October 29, 2015
BOARD OF COUNTY COMMISSIONERS
ORANGE COUNTY, FLORIDA

ADDENDUM NO. 5
IFB NO. Y15-771 PH
ORANGE COUNTY SOUTH WATER RECLAMATION FACILITY
PHASE V IMPROVEMENTS

ELECTRICAL
ELEMENTARY DIAGRAMS - SHEET 7

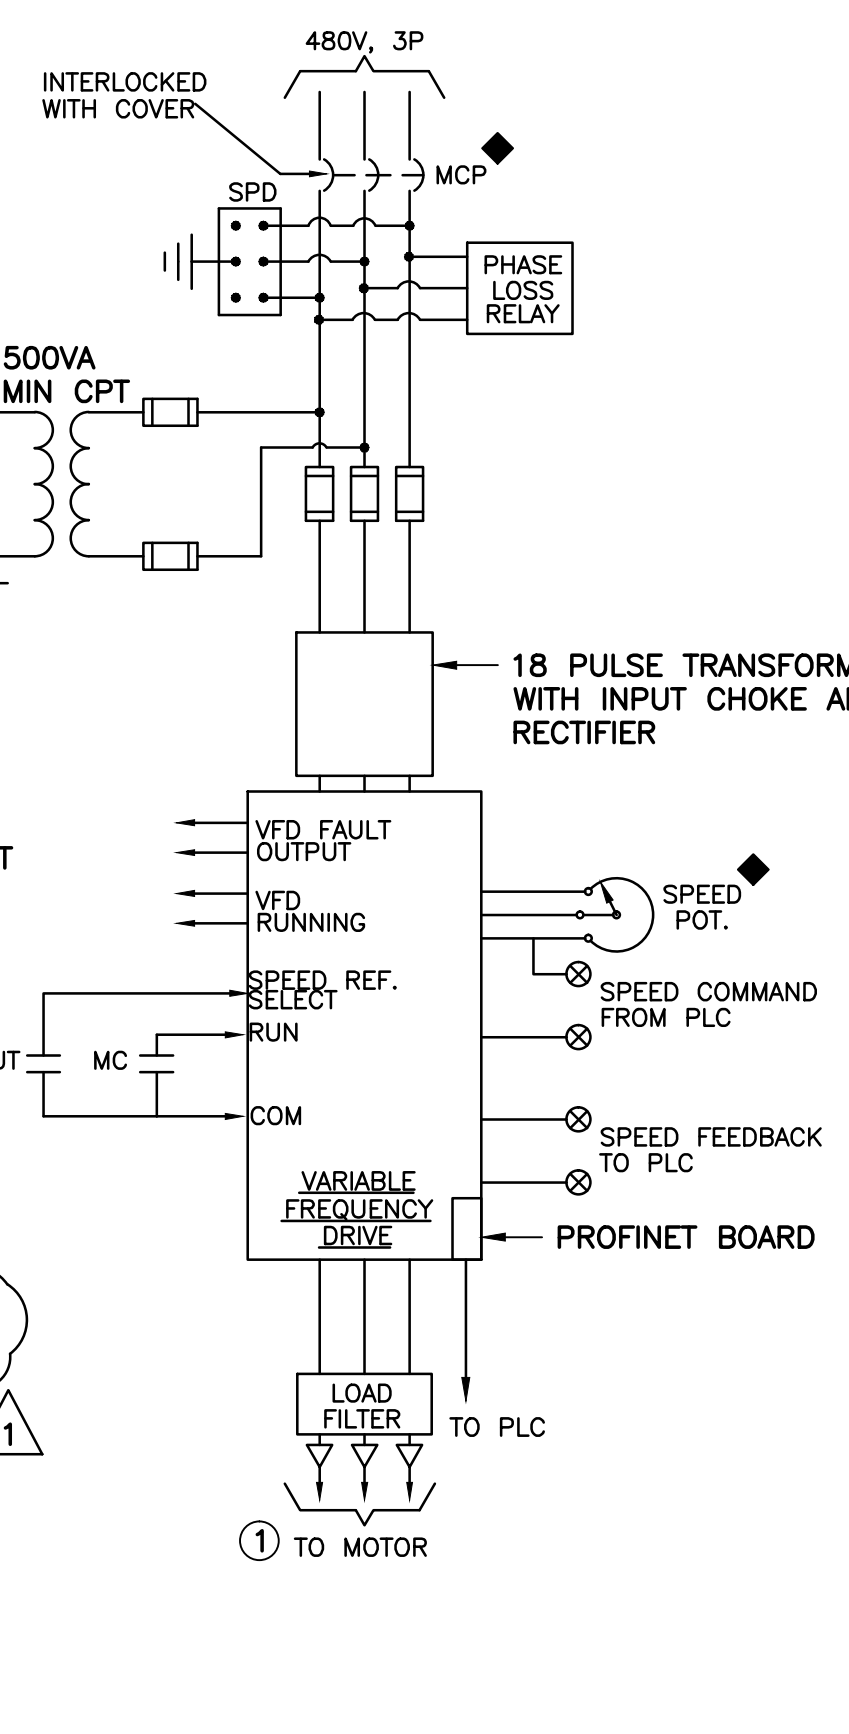
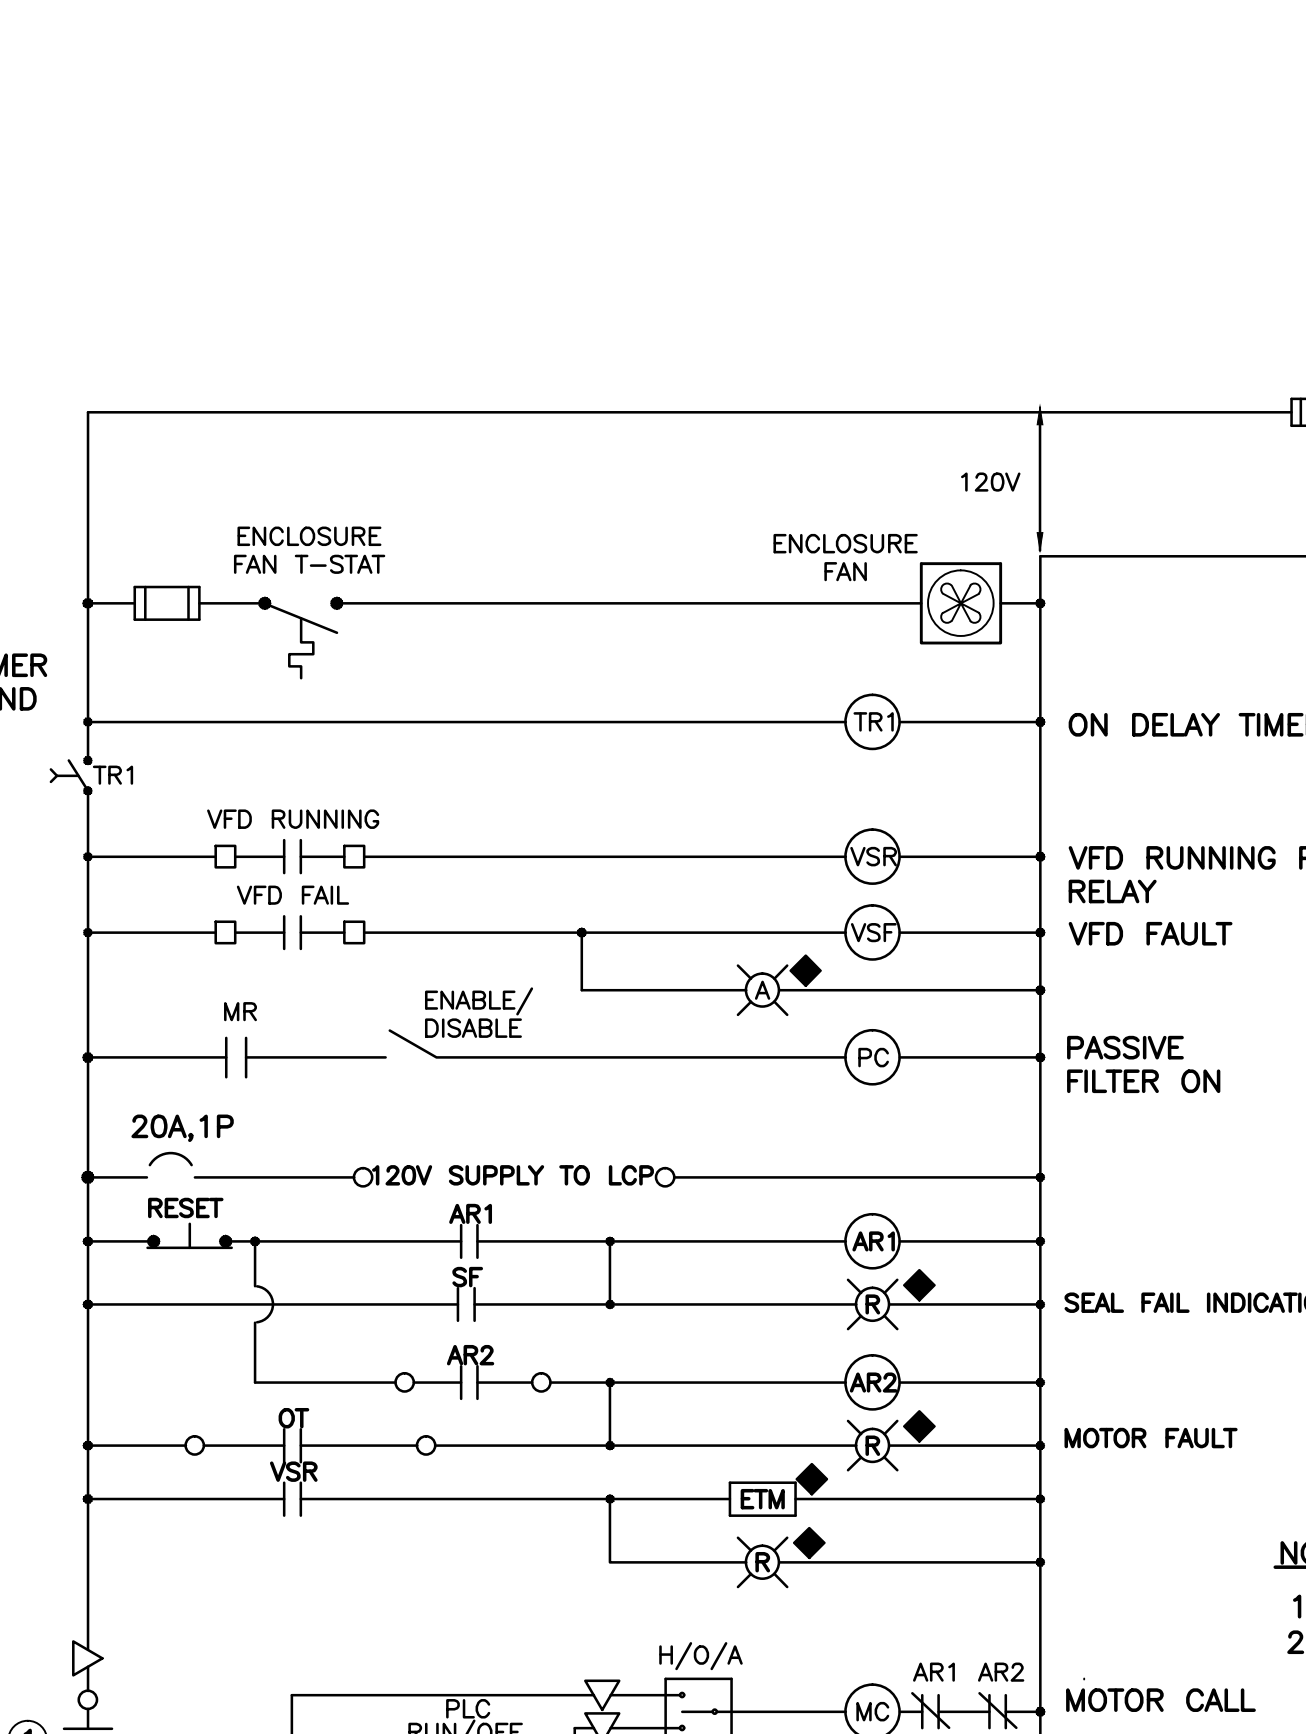
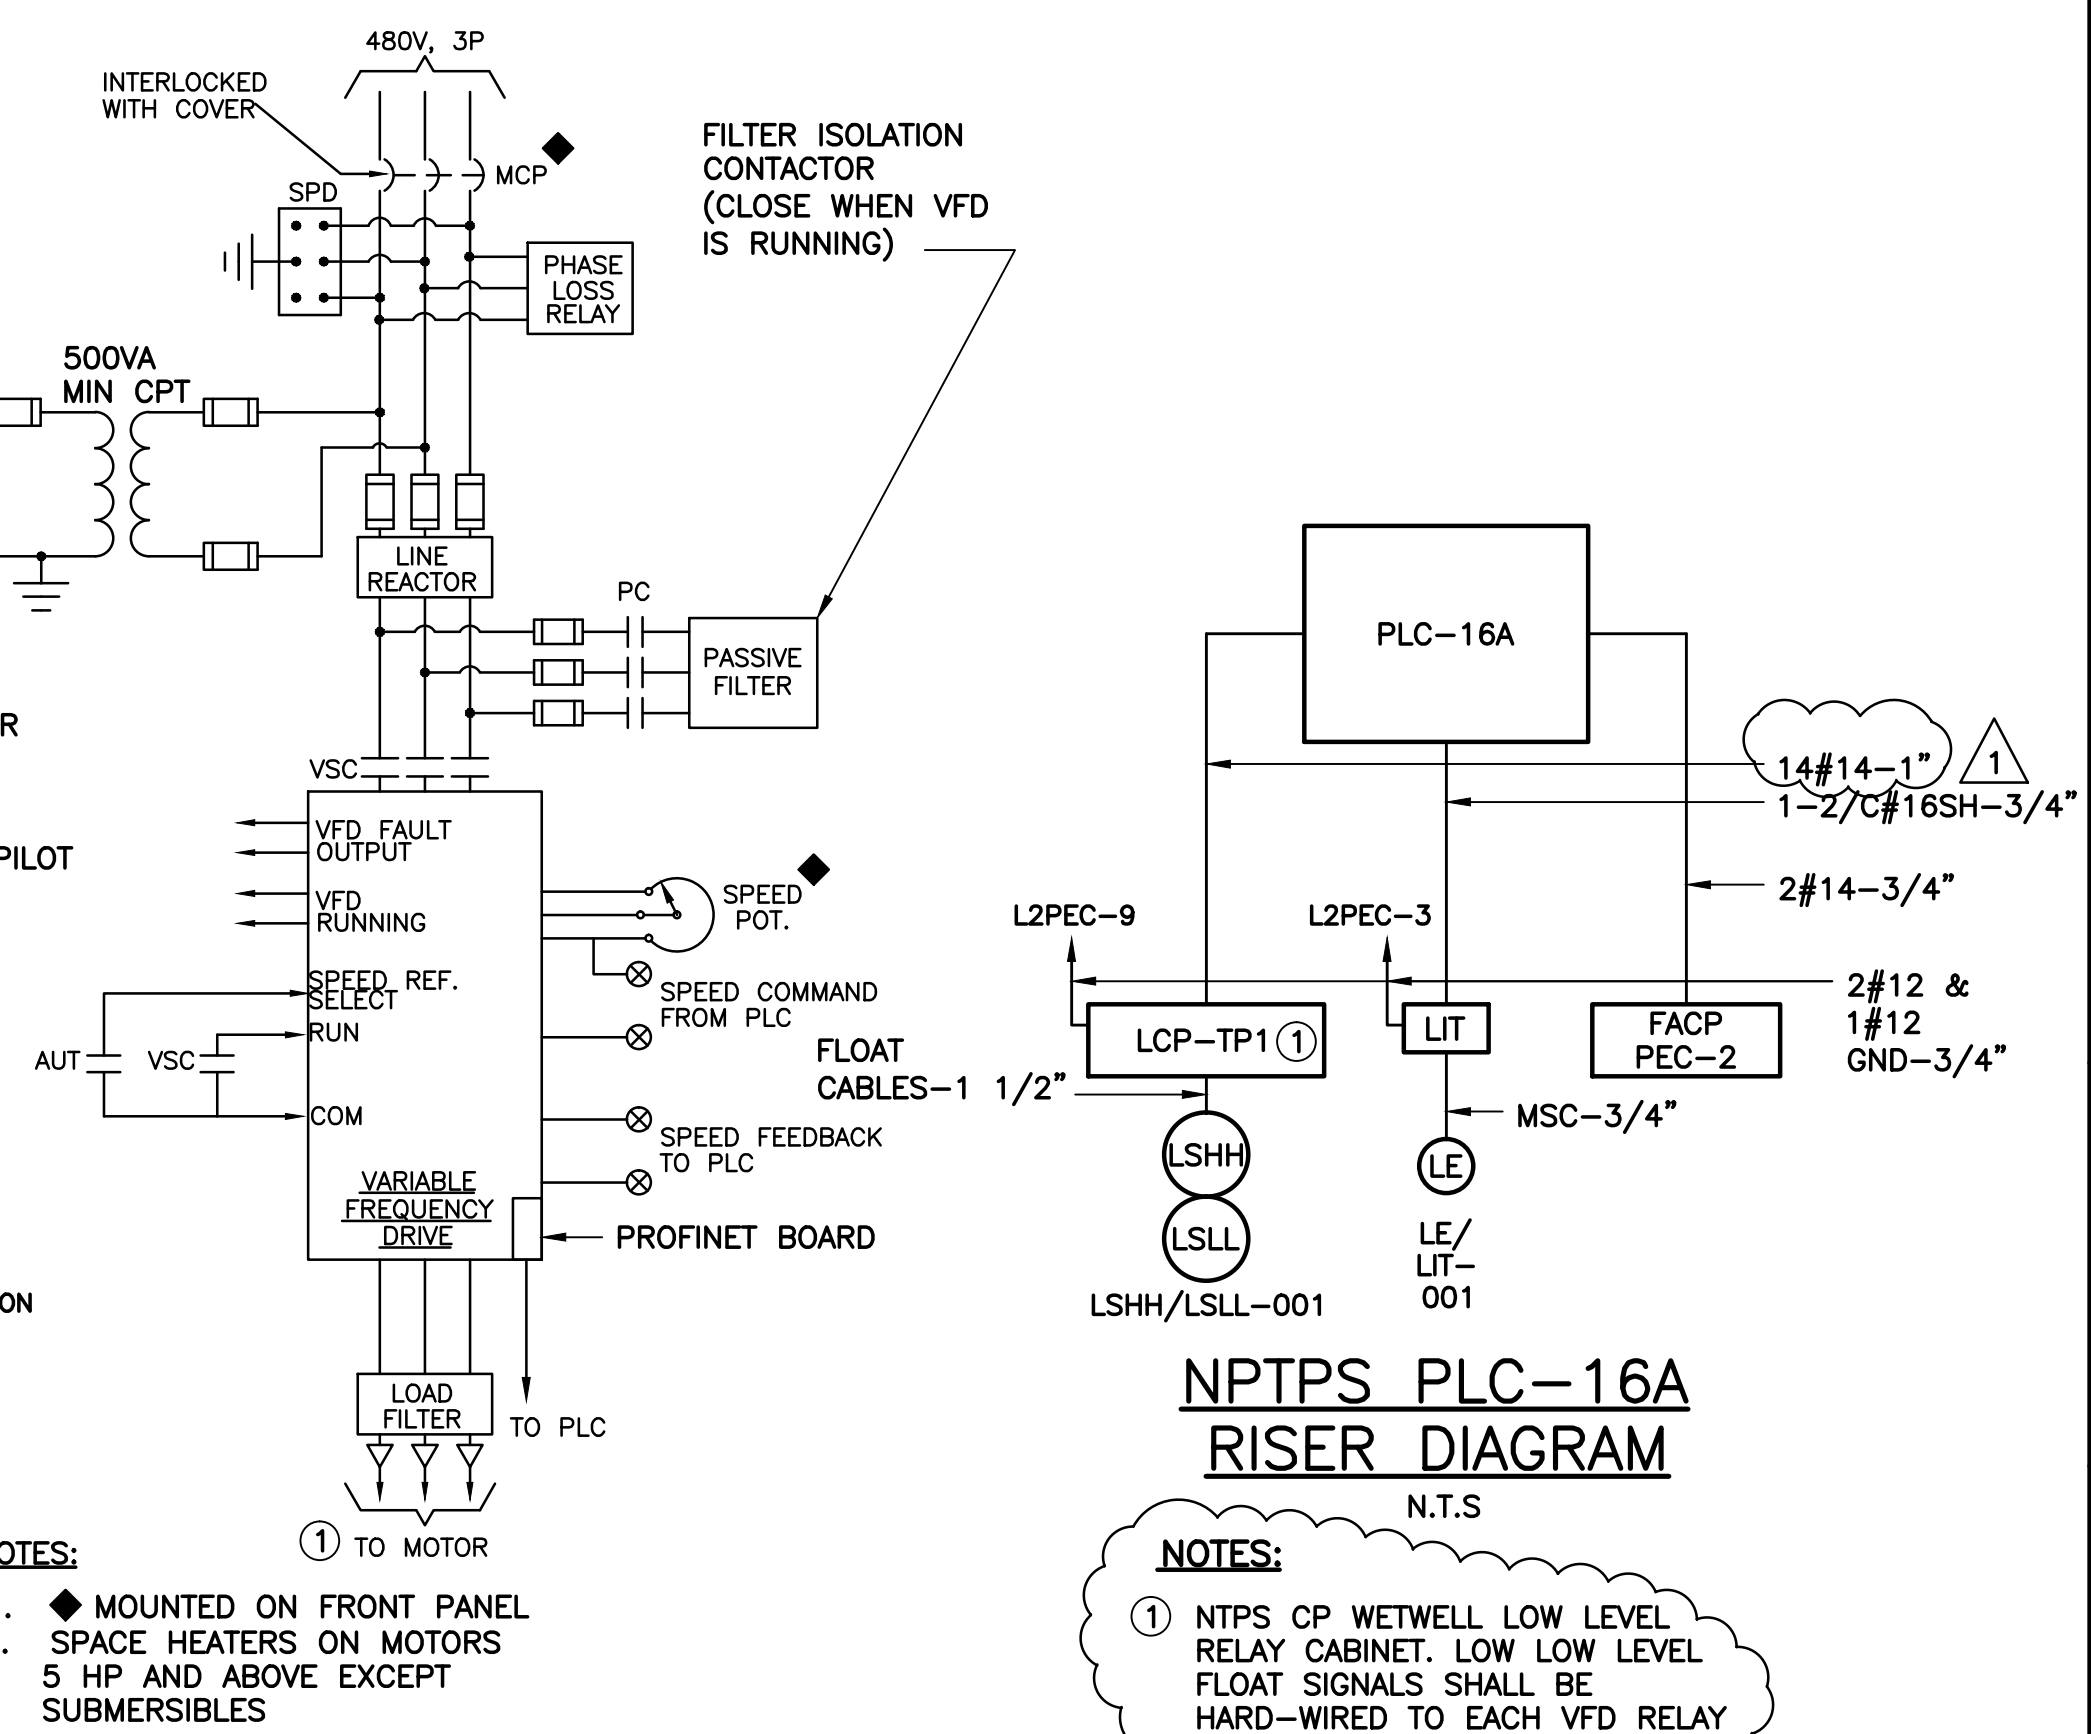
26. Sheet I-14, in addition to the low level indication to the PLC, add an electrical line from the interlock diamond of LCP-TP1 to the interlock diamond of each VFD with the wire transitioning through PLC-16A to each VFD to show the hard wired interlock on low level.

27. Sheet I-15, in addition to the low level indication to the PLC, add a PLC input labeled Equalization High High Wetwell Level. Also add an electrical line from the interlock diamond of LCP-EQ1 to the interlock diamond of each VFD with the wire transitioning through PLC-15B to each VFD to show the hard wired interlock on low level.
